RE: Docket No. 23-38-EL – The Narragansett Electric Company d/b/a
Rhode Island Energy's Petition for Acceleration of a System Modification
Due to Distributed Generation Project
Weaver Hill Projects
Responses to PUC Data Requests – Set 1

In Re: Rhode Island Energy's Petition for Acceleration Due To Distributed Generation Project – Weaver Hill Projects Responses to the Commission's First Set of Data Requests Issued on November 17, 2023

<u>PUC 1-4</u>

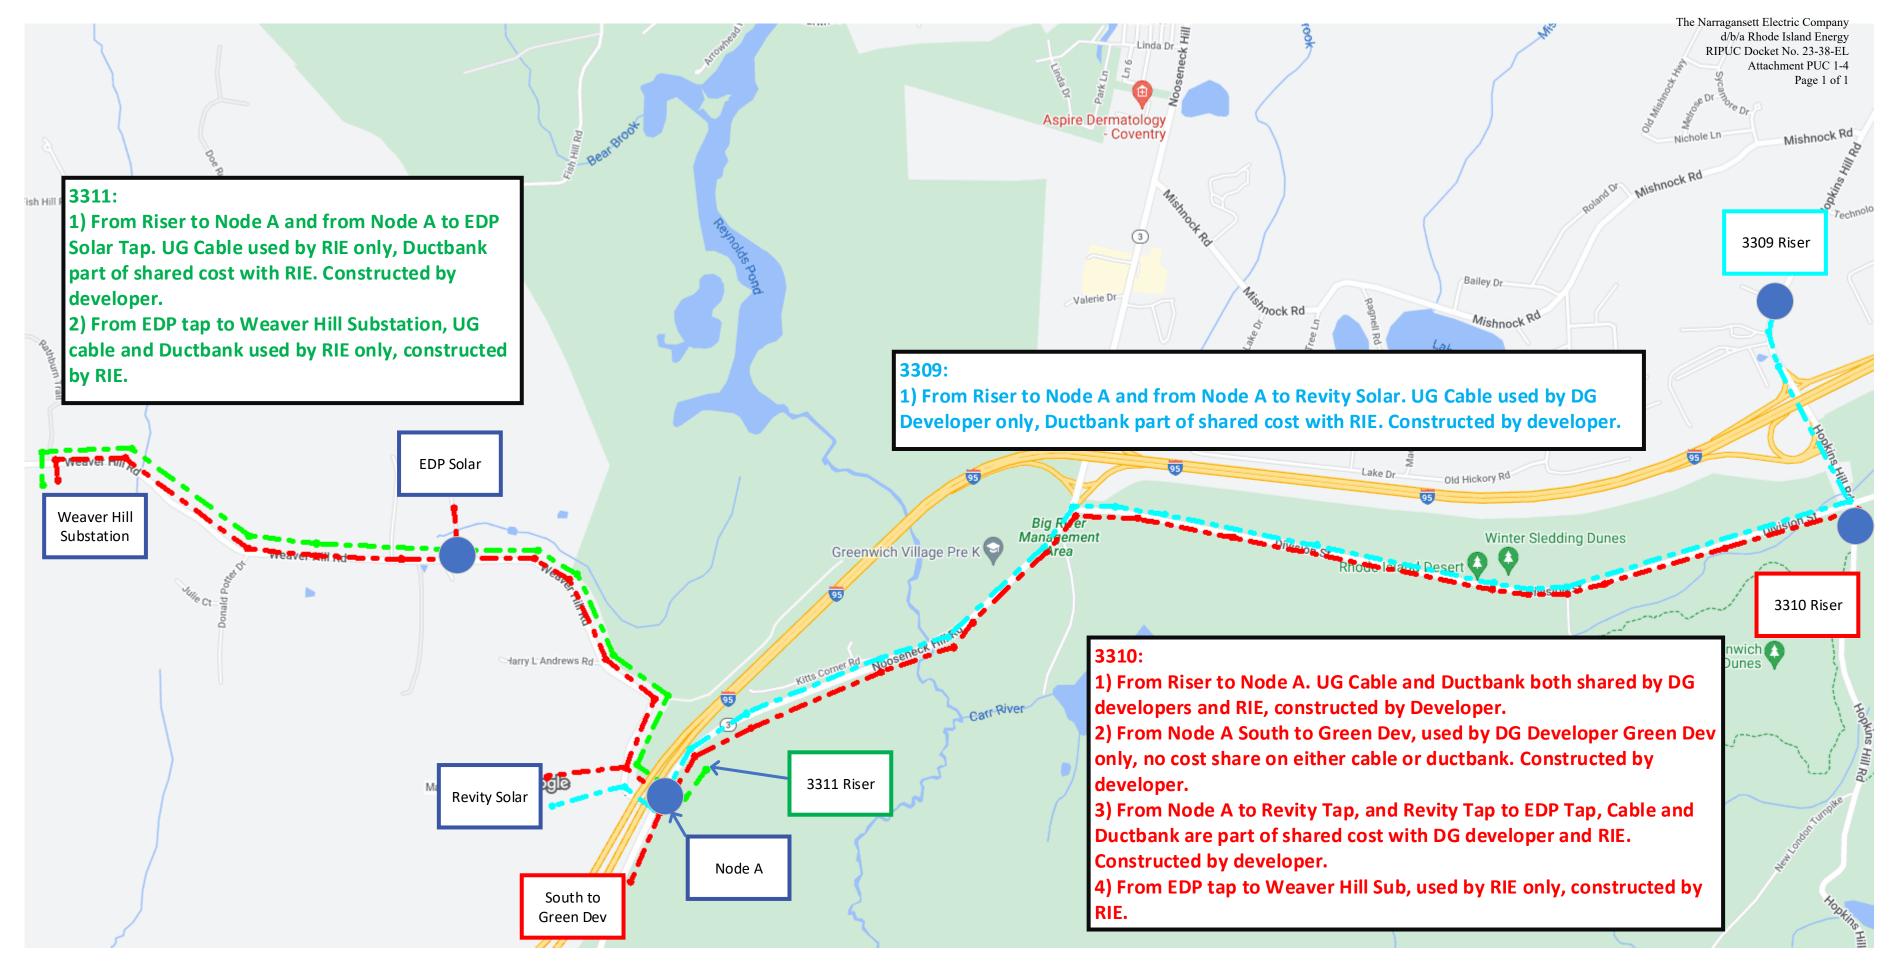
Request:

Please provide an aerial map that shows, using different colors, the components of the project by those that came out of the area study (System Improvements/accelerated system modifications), developer constructed civil work, developer System Improvement responsibility, etc.

Response:

A map is provided in Attachment PUC 1-4.
